**CITY OF MOUNDSVILLE
MARSHALL COUNTY, WEST VIRGINIA
FOUR SEASONS SPLASH PAD**

ADDENDUM #1

April 1, 2021

THRASHER PROJECT #030-10204

PARTS LIST			
ITEM	QTY	PART NUMBER	DESCRIPTION
13	1	BOL-005	6" BOLLARD, TOUCH SENSOR
16	1	TMR-008	TIMER PANEL

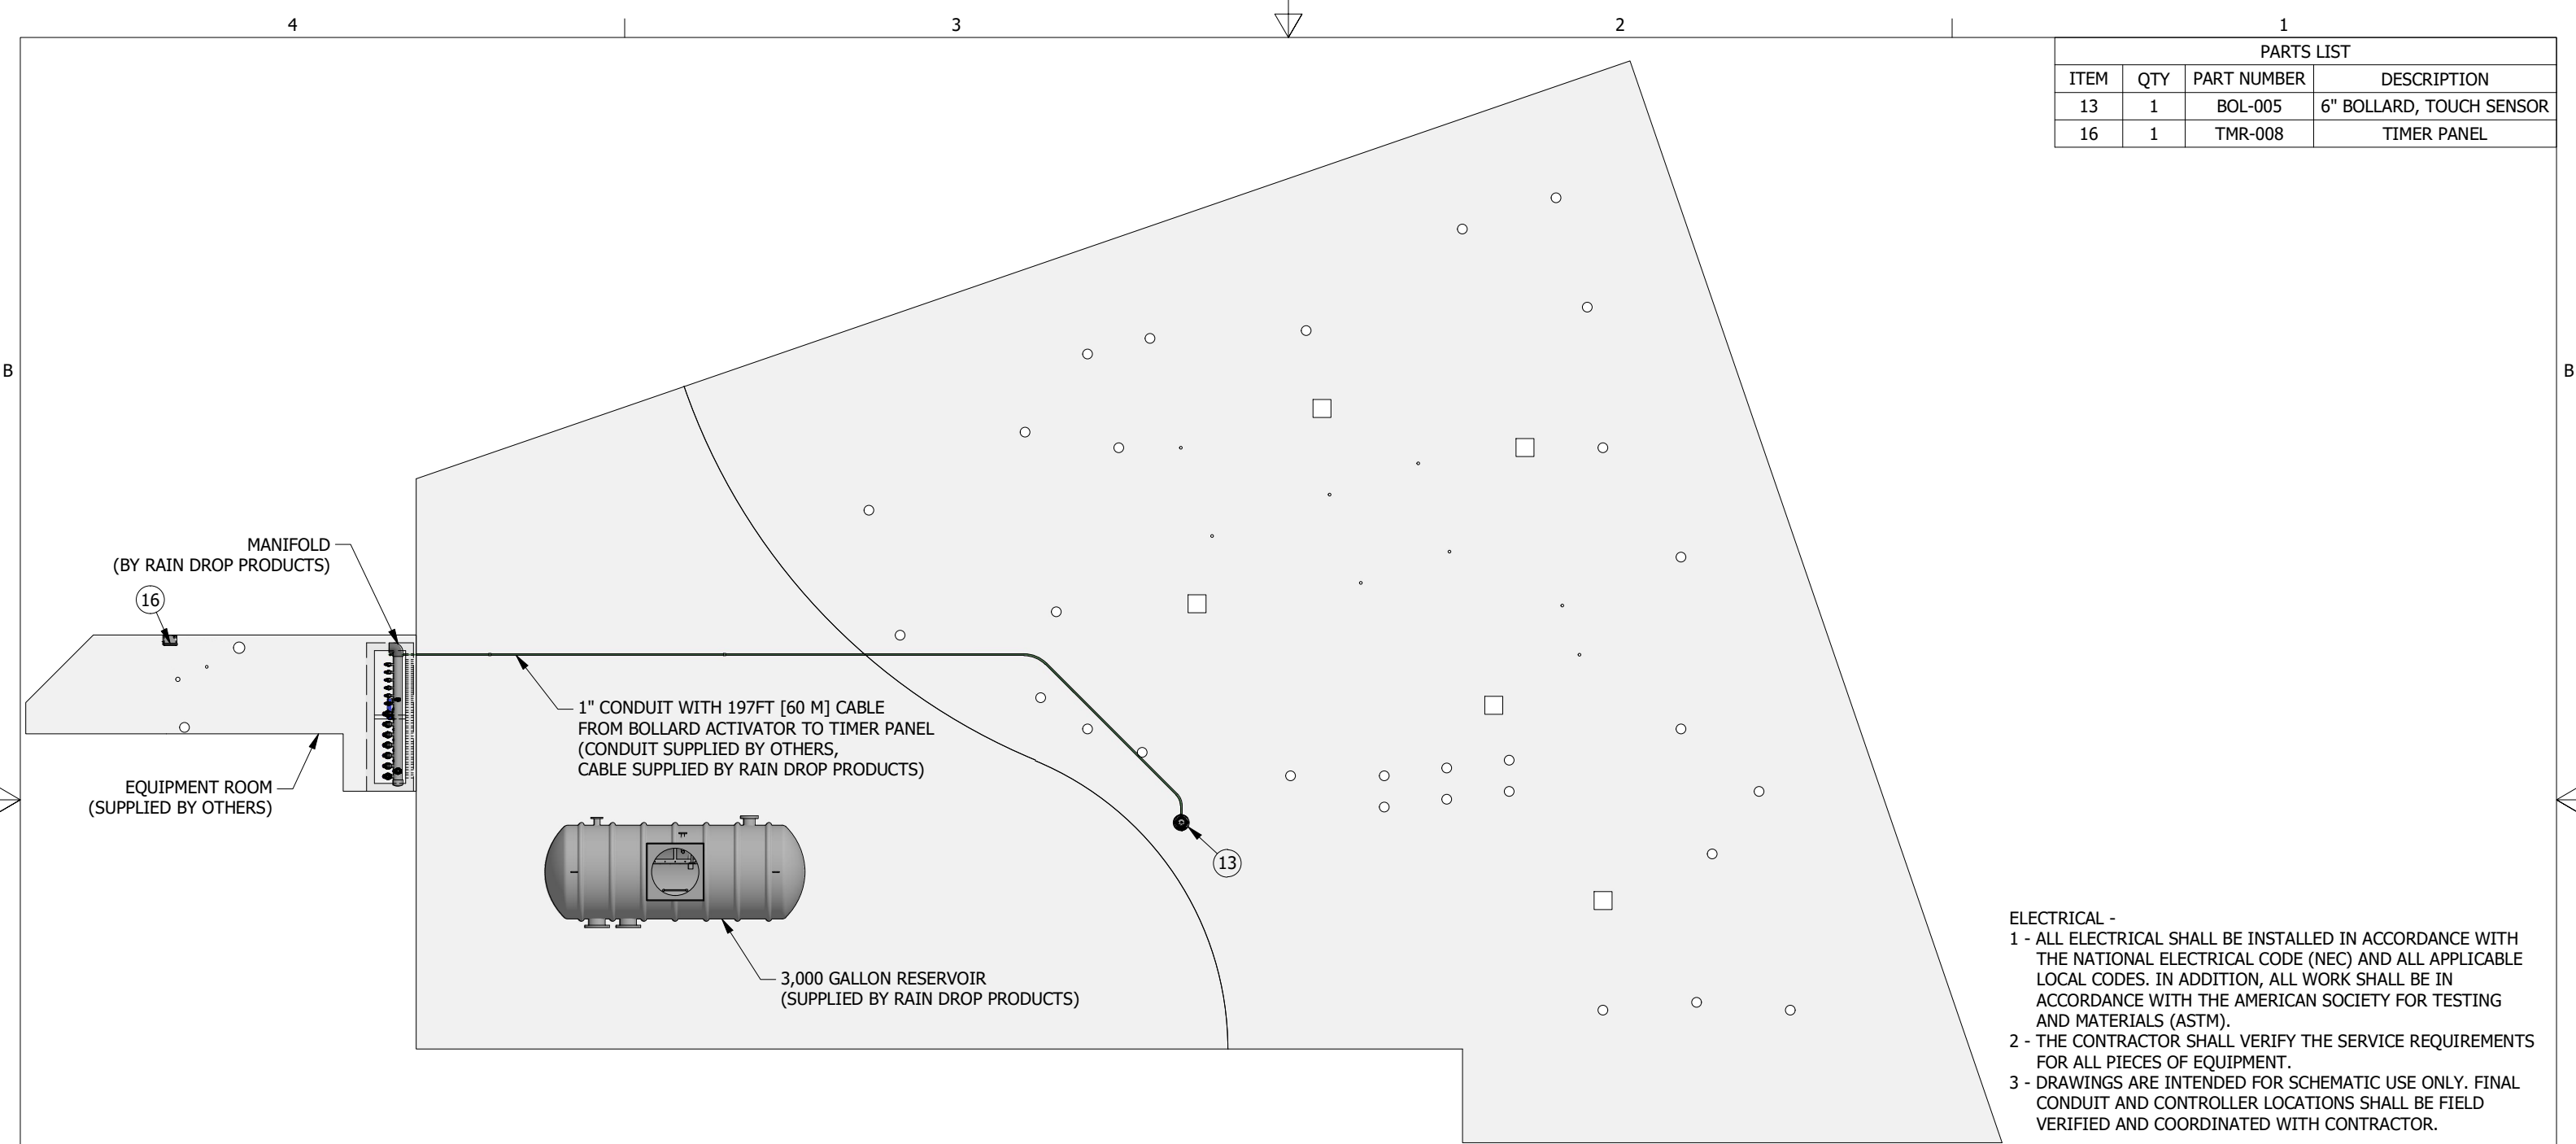
Is there a scaled Rain Drop drawing in order to arrive at the footages of piping required to connect from the manifold to their equipment? Same scenario for the drain piping and the area drains.

Sheets 4 of 11, 5 of 11, and 6 of 11 of the Rain Drop plan sheets are scaled at 1" = 10' when printed at 11x17 with no page scaling.

THRUST BLOCK DETAILS
NOT TO SCALE

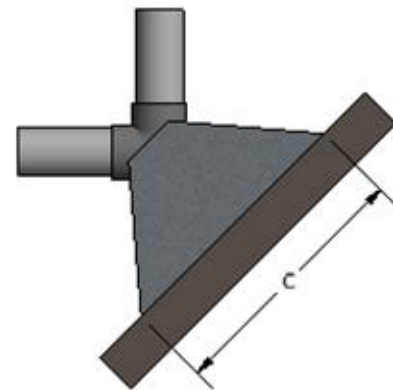
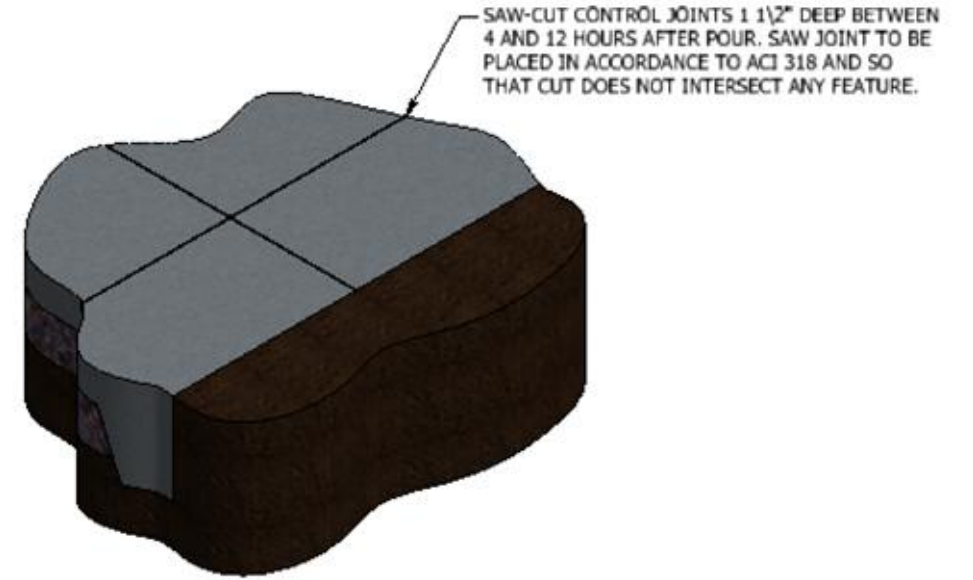
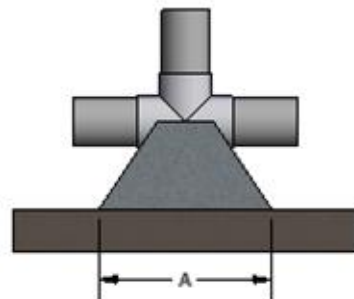
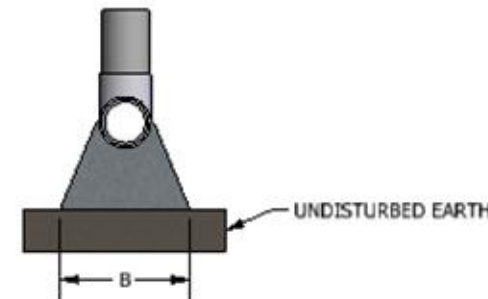
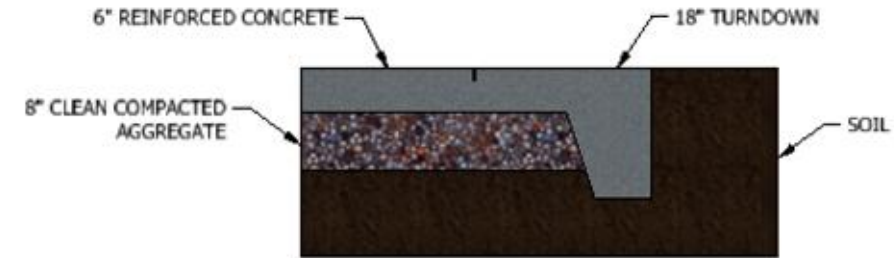
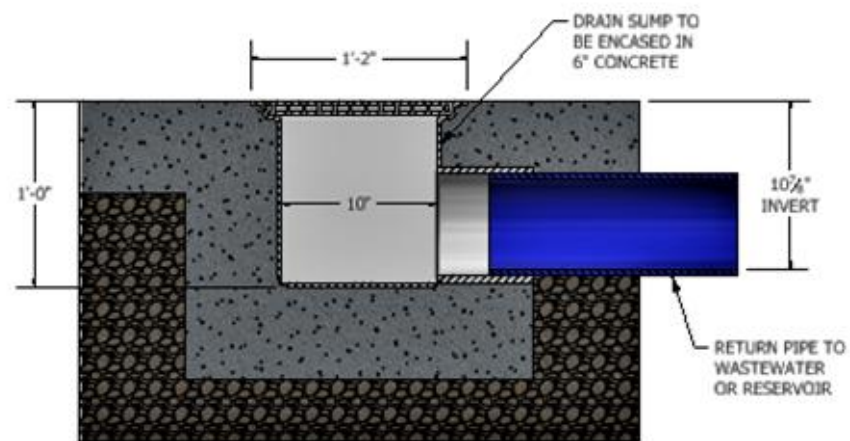
Where are the thrust blocks to be installed as per Rain Drop drawing 11 of 11? All supply piping is 1" or 2". Sizes shown on the schedule are 4" and larger.
